Action Transmittal

Action Transmittal: 2024-05

Scope Change Request for Saint Louis Park Cedar Lake Road and Louisiana Avenue Improvements Project

RE: Scope Change Request for SP 163-296-006 & SP 163-296-007

Attachment 3
SP 163-296-006 & 163-296-007

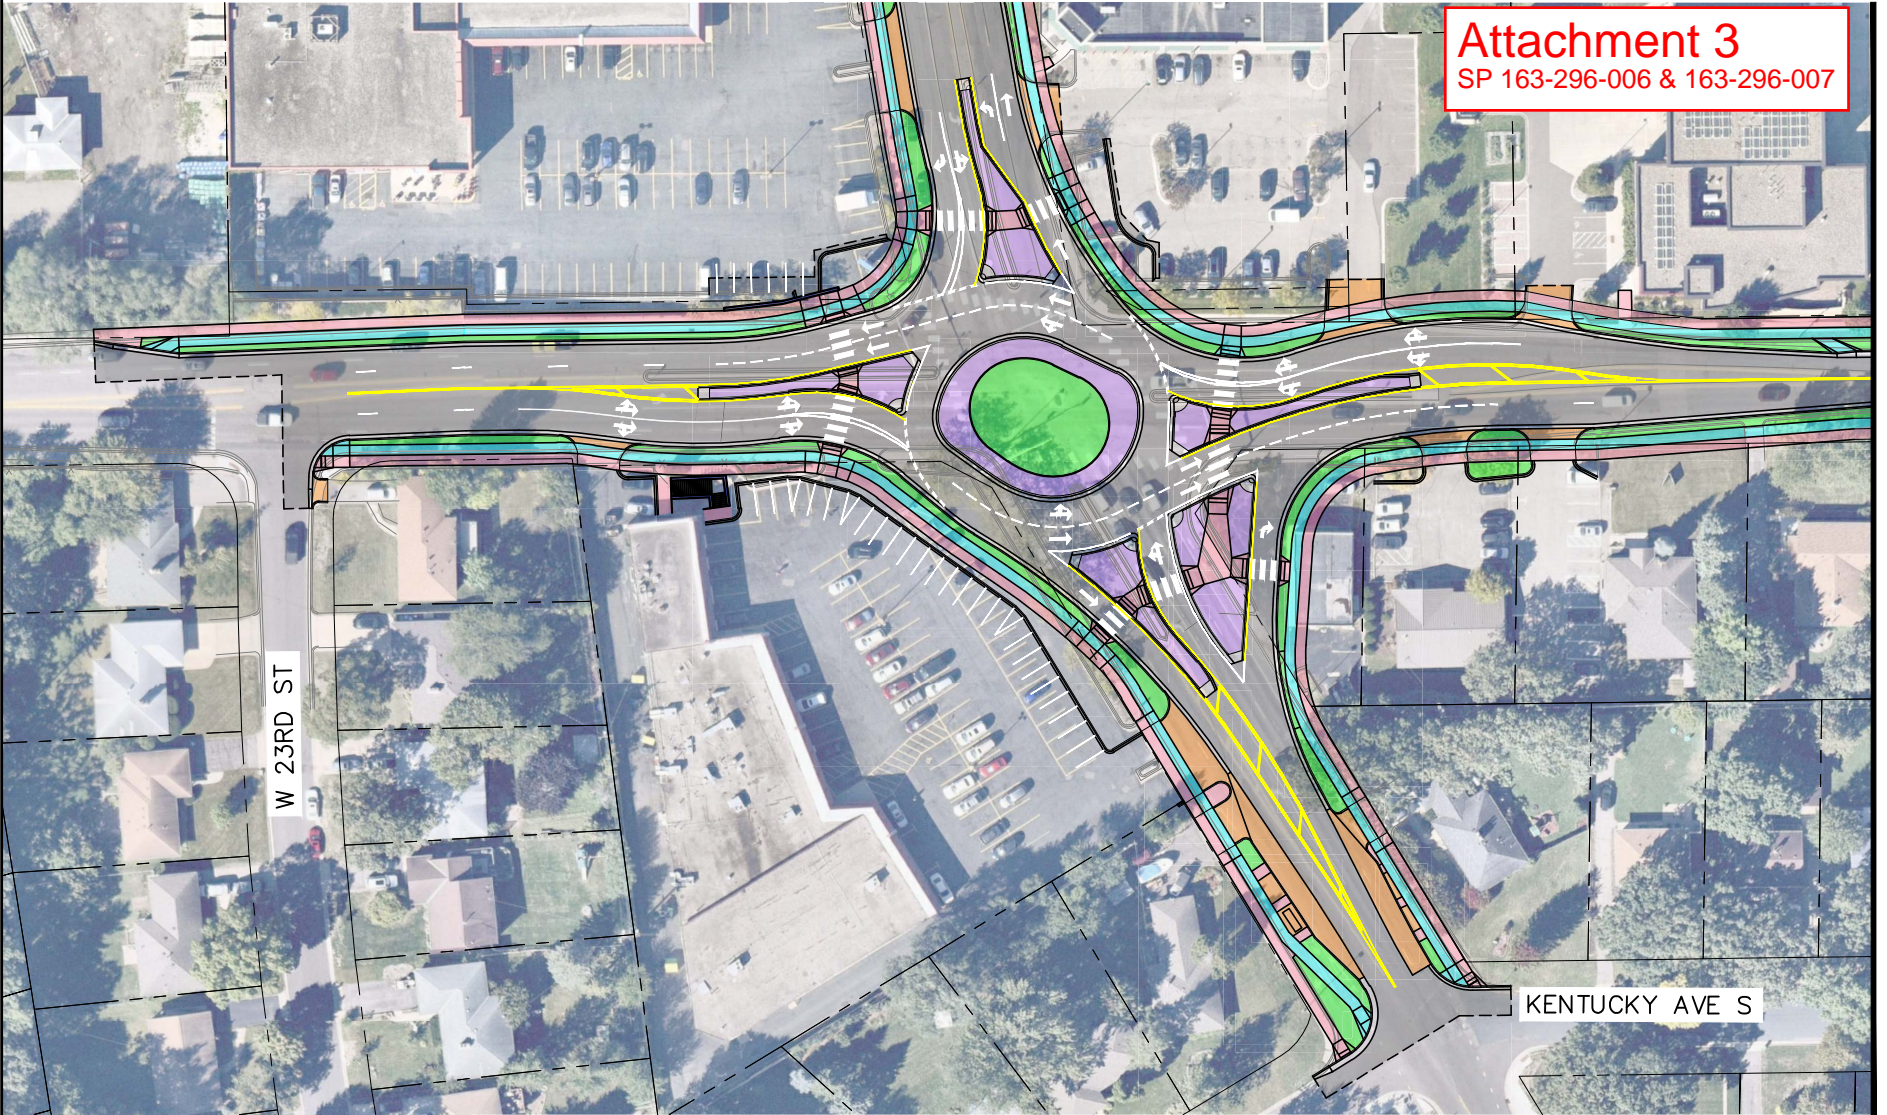
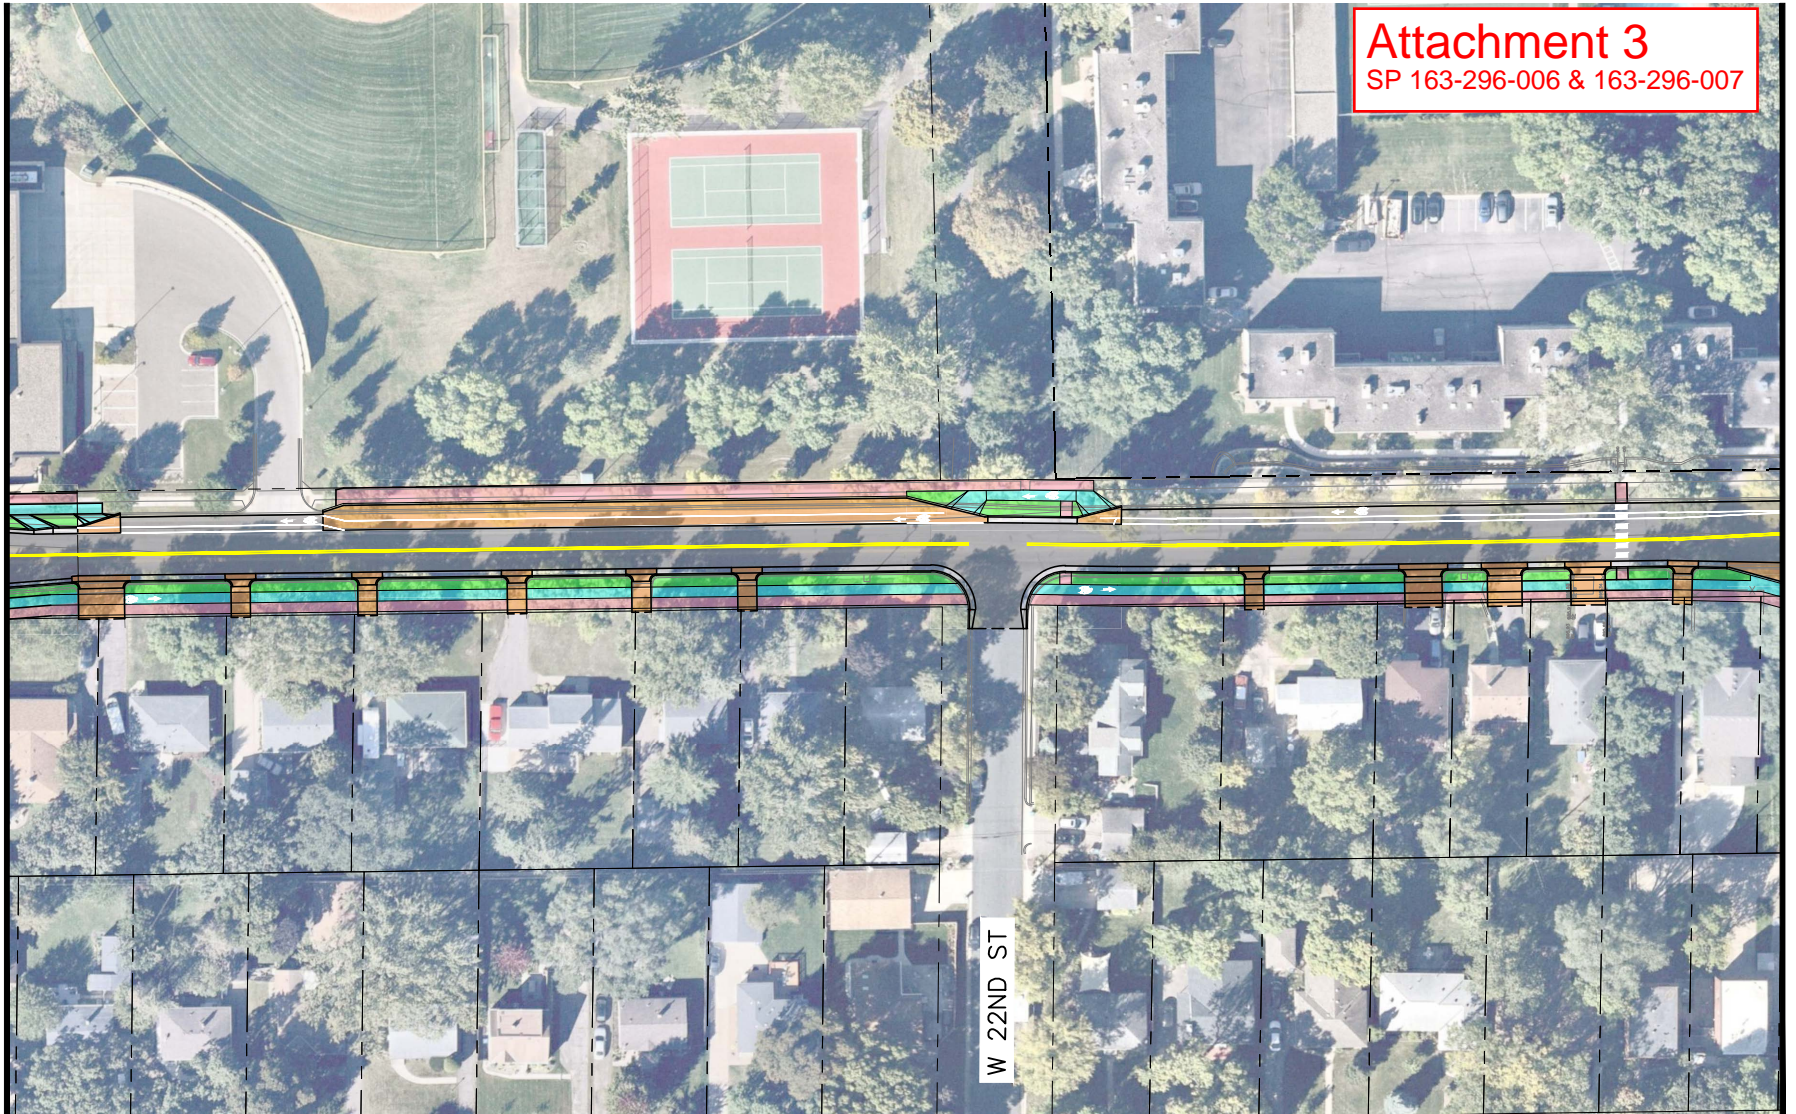
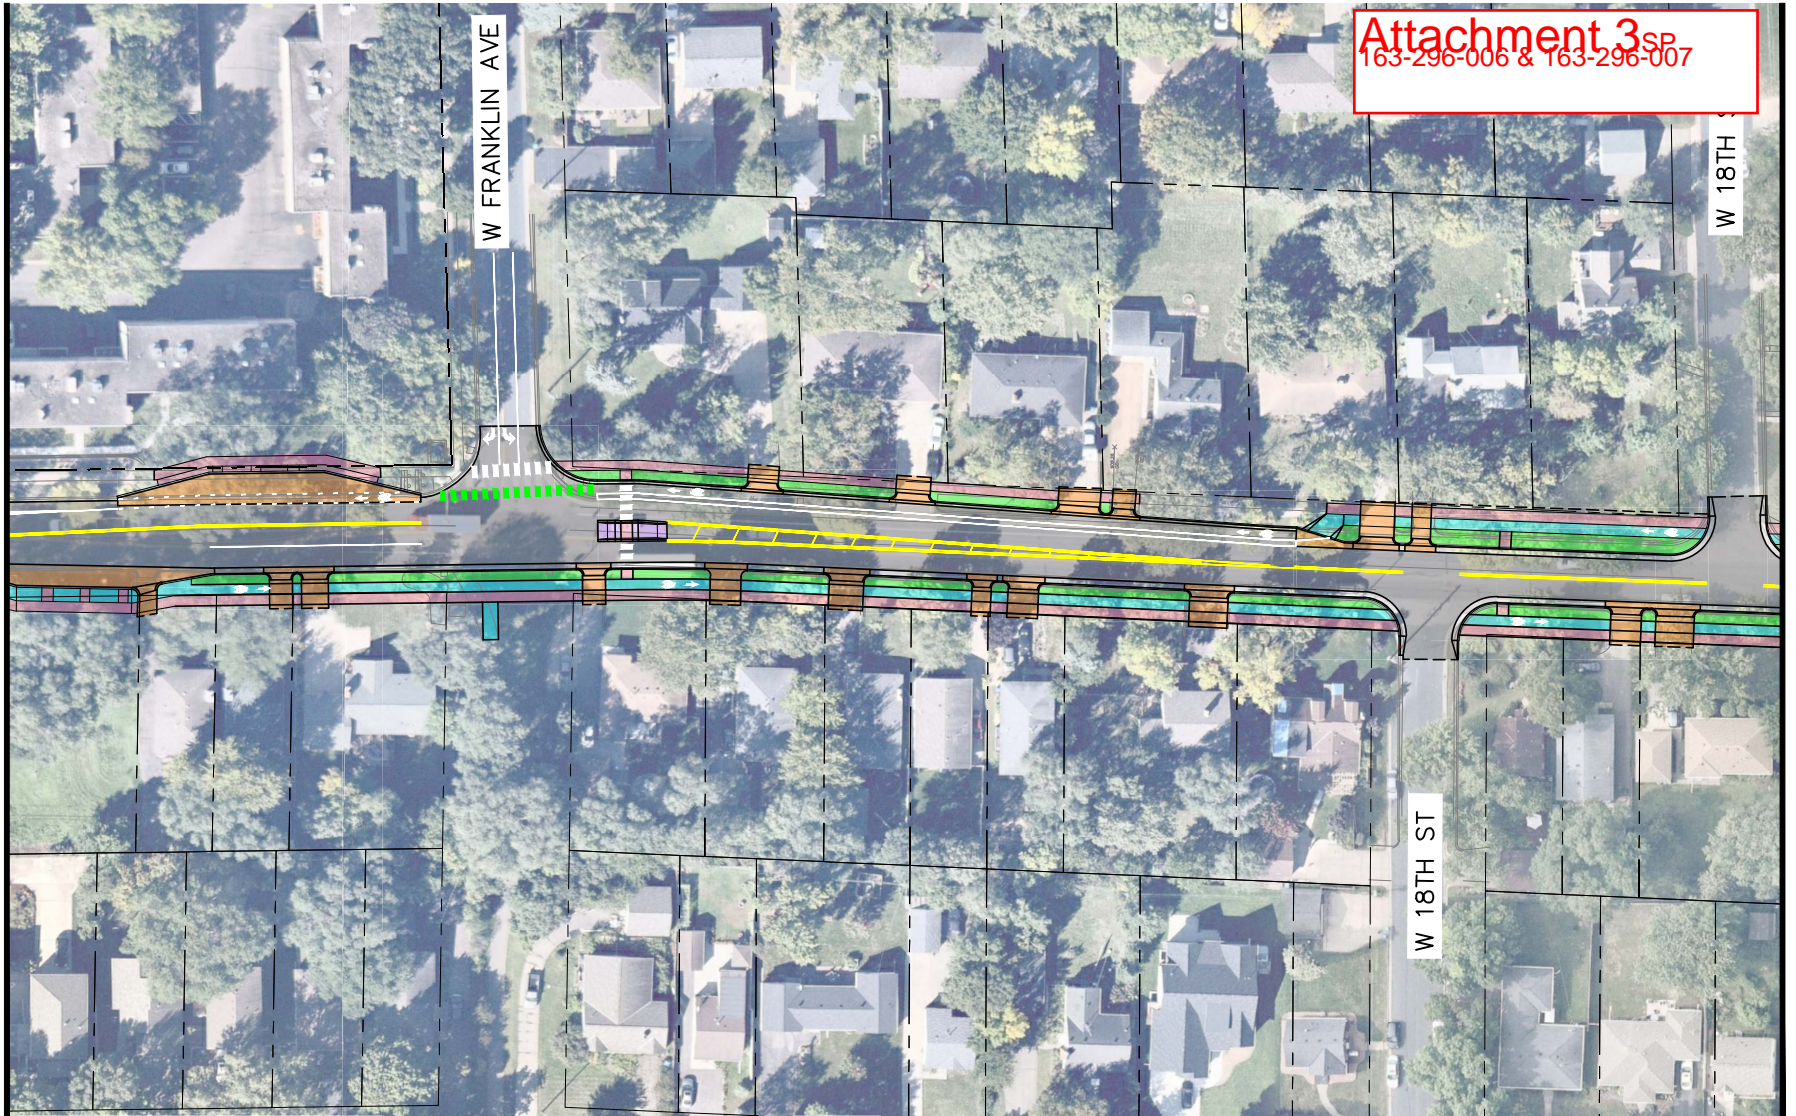
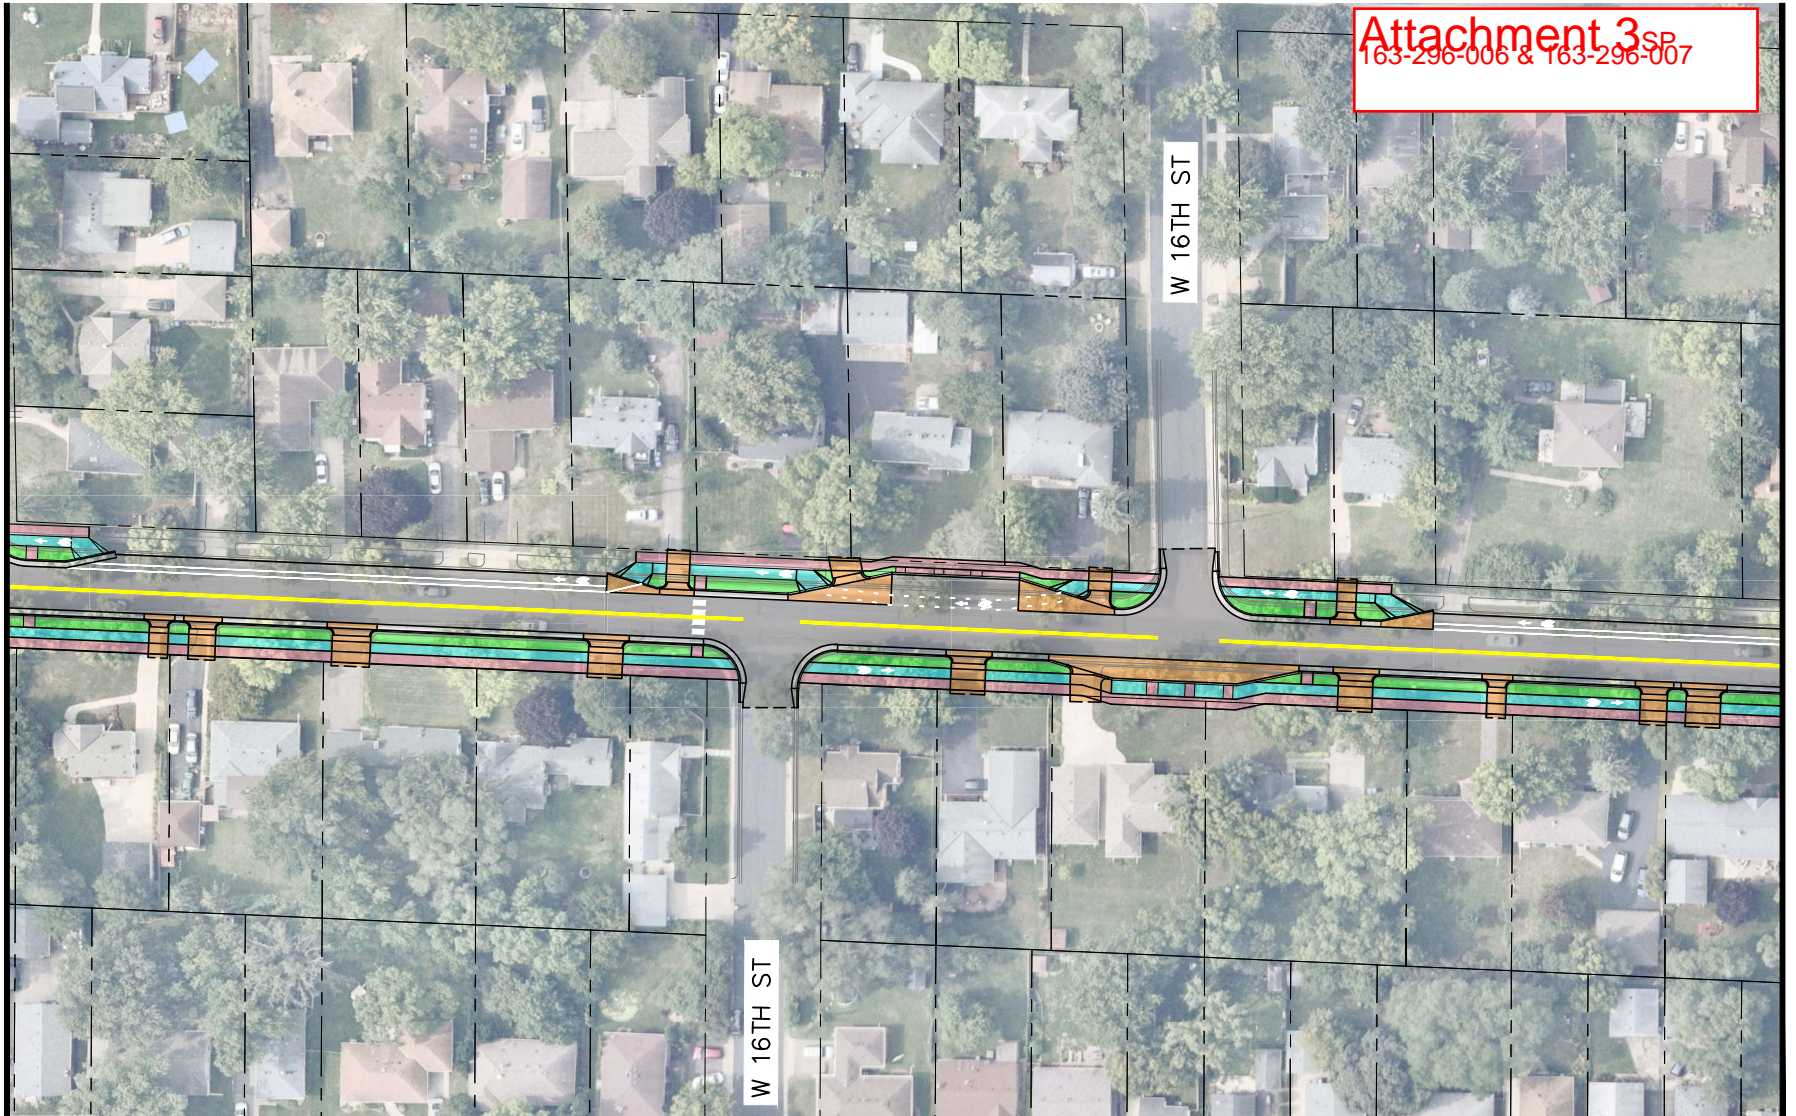
application design. The formal scope change for Louisiana Avenue includes modifying the bicycle facility as described in the table below and shown in Attachment 4 and Attachment 5.

Louisiana Avenue Bicycle Facility Summary		
Location	Funding Application Design	Current Design
Louisiana Avenue: 23rd Street to Cedar Lake Road (400 feet)	Protected one way cycle track in each direction Sidewalk on both sides of the road	Shared use trail on both sides of roadway
Louisiana Avenue: Cedar Lake Road to 22nd Street (900 feet)	Dedicated on street bike lanes or protected one way cycle track in each direction Sidewalk on east side of the road	Shared use trail on west side of roadway Sidewalk on east side of the road
Louisiana Avenue: 22nd Street to 14th Street (2500 feet)	Dedicated on street bike lanes or protected one way cycle track in each direction Sidewalk on east side of the road	*Dedicated bike routes using parallel side streets and trail Sidewalk on east side of the road
Louisiana Avenue: 14th Street to Wayzata Blvd (300 feet)	Protected one way cycle track in each direction Sidewalk on east side of the road	Shared use trail on both sides of roadway
